REQUEST FOR INFORMATION

RFI NUMBER	NL-RFI-048				
ISSUE DATE (YY/MM/DD)	July 9, 2011				
PRIORITY	H	X	M		L
REQ'D RESPONSE DATE	June 15, 2011

Hope Bay Mining Project

Subject:	Surfacing Crush Blend	Project Zone/Area:	Site Wide
Company:	Nuna Logistics Ltd. (Nuna)	Station/Location:	Per information request
Attention:	Ishan Fechter, Pat Dillon	Discipline:	Civil

Figure. 1

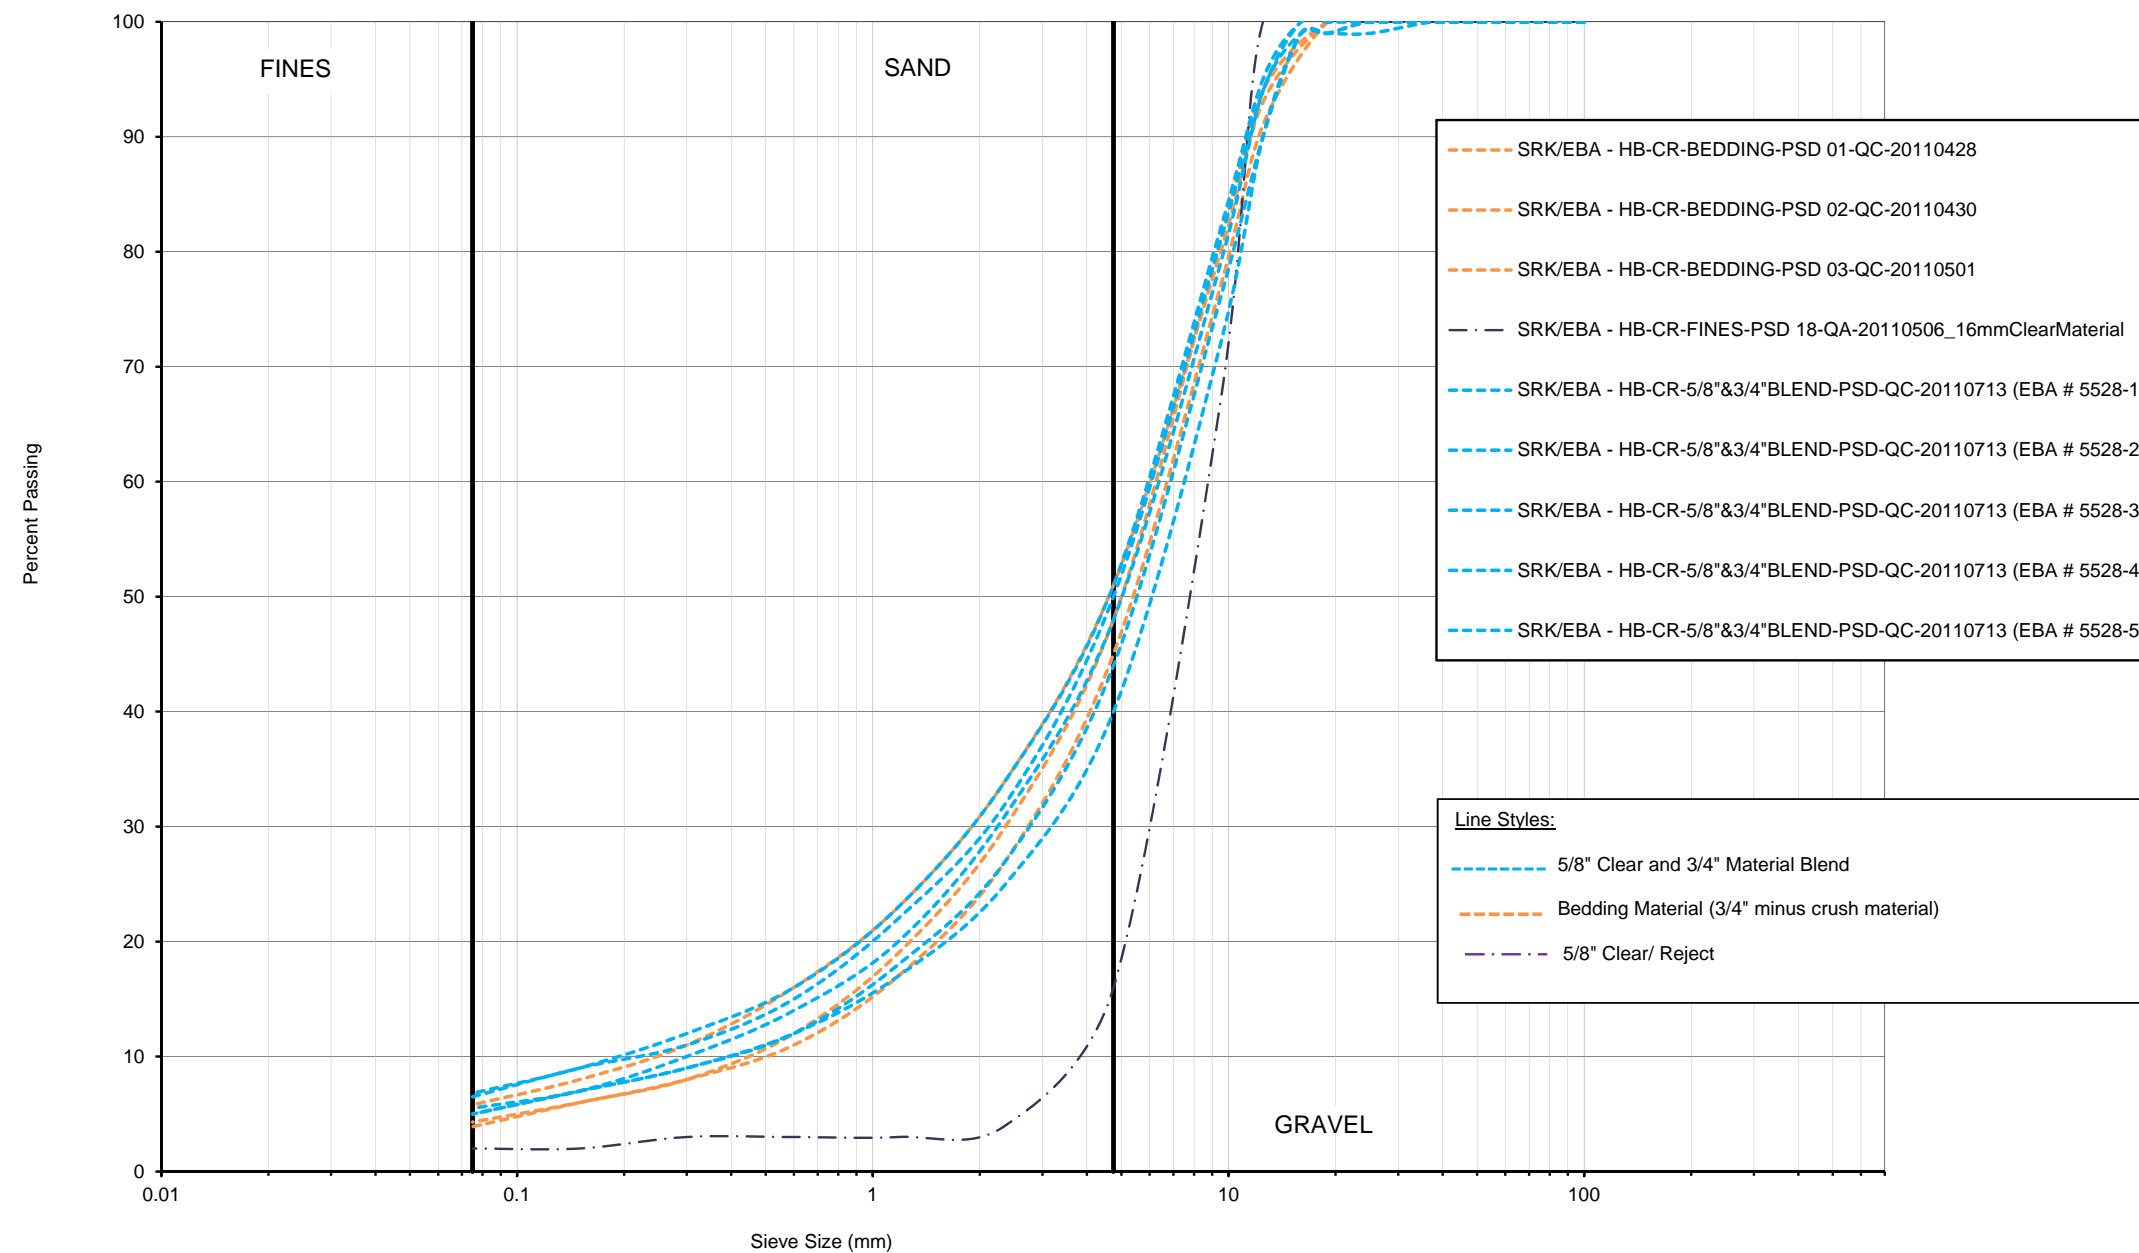
Nuna proposes the blending of ¾" crush with 5/8" crush to extend surfacing material volumes until the crushing program resumes in September 2011. The 5/8" crush was a byproduct of North Dam Frozen Core Material (Fines) production and stockpile volume onsite is more than adequate to supply the current scope.

Nuna requests SRK/EPCM approval to produce a 2:1 ¾" crush to 5/8" crush blend for use in the following applications:

SRK had five samples of the blended material submitted to EBA's lab in Yellowknife for Particle Size Distribution [PSD] analysis. A summary graph of the PSD for the blended material, 3/4" crush, and 5/8" reject is attached. The summary graph indicates the blended material has a PSD similar to the 3/4" crush. Visual observations, of placed material, in the field indicate the blended material does achieve initial compaction but becomes loose over time when left exposed. Based on the PSD and visual observations, the blended material would be suitable for items 2,4,5,7,8,9,12, and 13 above. This material cannot be used for item 1, 3, 6, 10, and 11.
